SERVICE BULLETIN

**MADELEC AERO
(F9503)**

ICE AND RAIN CONDENSATION - LIGHTED ICING INDICATOR PNR 864-001

IMPROVEMENT OF ILLUMINATION device RELIABILITY (Upgrade to Amendment A)

Figure 1
Disassembly of the unit

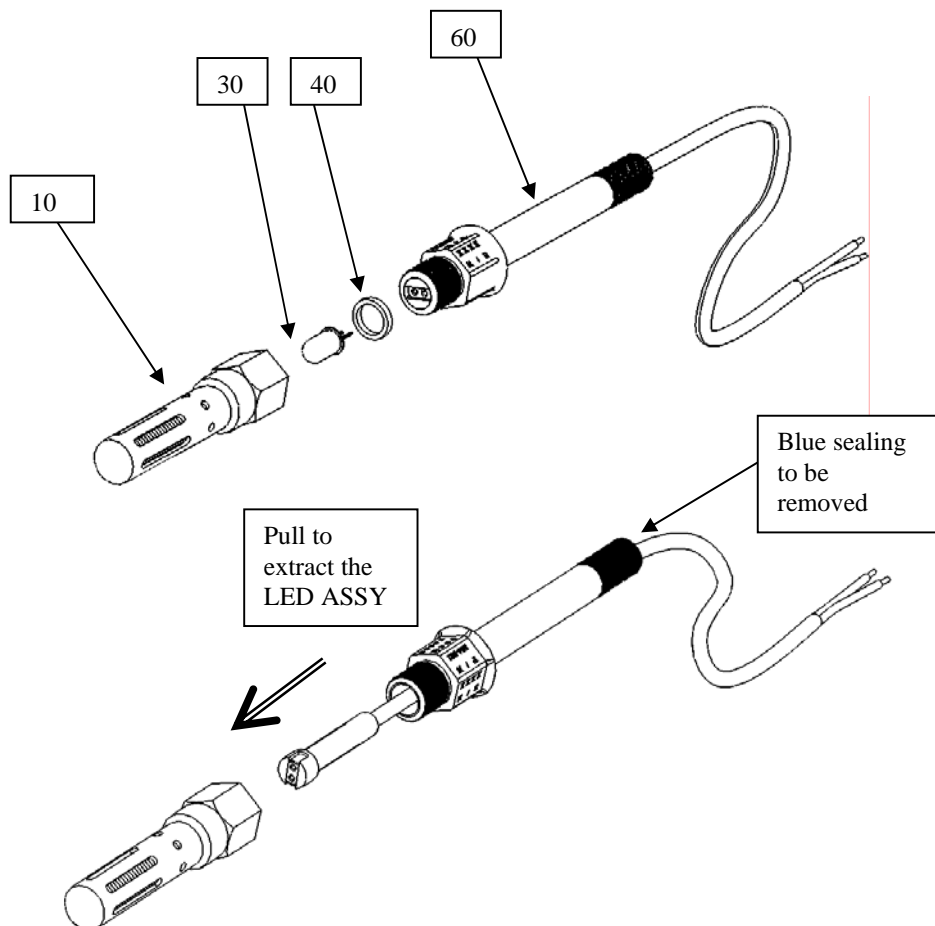
- (1 Diisassemble the equipment to gain acces to the LED Assy.
)
- (2 Unscrew the COVER (10) from the MAIN PART (60).
)
- (3 Remove and discard the SEAL (40) from the COVER (10) and pull to remove the GREEN LED (30)
)
- (4 Remove the blue sealing from the wires junction at the rear of MAIN PART (60).
)
- (5 Push using set of wires to extract the old LED ASSY from the MAIN PART (60).
)
- (6 Scrap the removed LED ASSY.
)

Figure 2
Modification of the unit

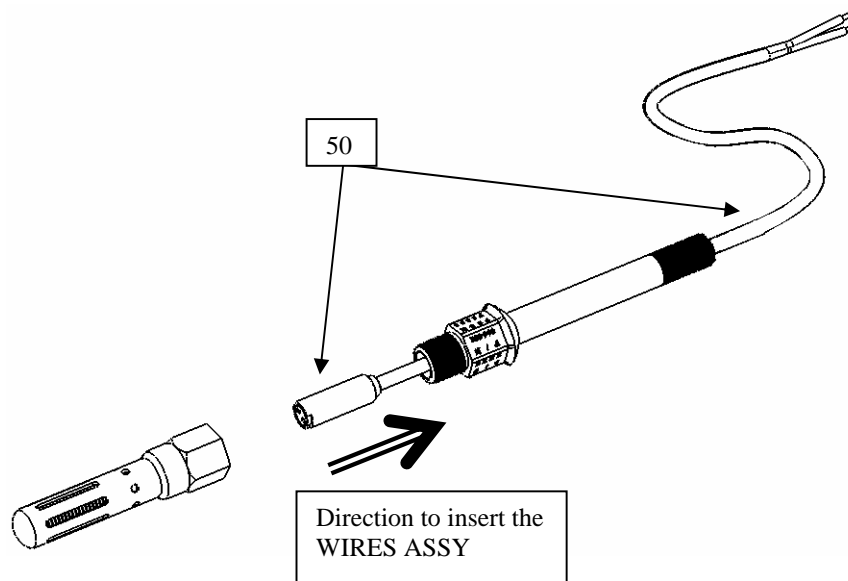
- (1 Replacement of the old LED Assy.
)
- (2 Install the new WIRES ASSY (50) inside the MAIN PART by inserting first the wires.
)
- (3 Make sure that the assy is corrected installed in order to allow the assembly of MAIN PART
) (60).

Figure 3
Assembly of the modified equipment

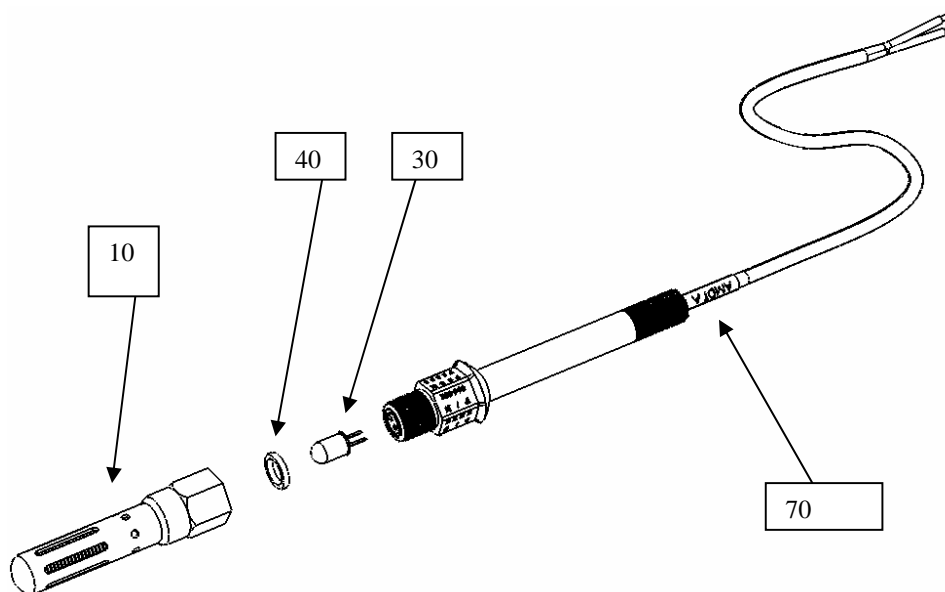
- (1 Install GREEN LED (30) into the relevant MAIN PART (60) socket.
) Please note the polarity of the LED in accordance with ACMM 30-81-12 (SUBTASK 30-81-12-440-001-A01).
- (2 Put the SEAL (40) in position inside the COVER (10) equipped with its internal plastic diffuse r.
) r.
- (3 Apply adhesive Loctite 243 (MIL S 46163) on thread of MAIN PART and torque the COVER (10) between 3.95 and 4.05 N.m.
) (10) between 3.95 and 4.05 N.m.
- (4 Apply sealant JS 544 at the interface between MAIN PART (60) and wire assembly
) Please do not move during the 24H hour sealant drying period.
CAUTION: the sealing application shall not affect the quality of thread used for aircraft interface fastening.
- (5 Re identify Part marking in accordance with section E.
)
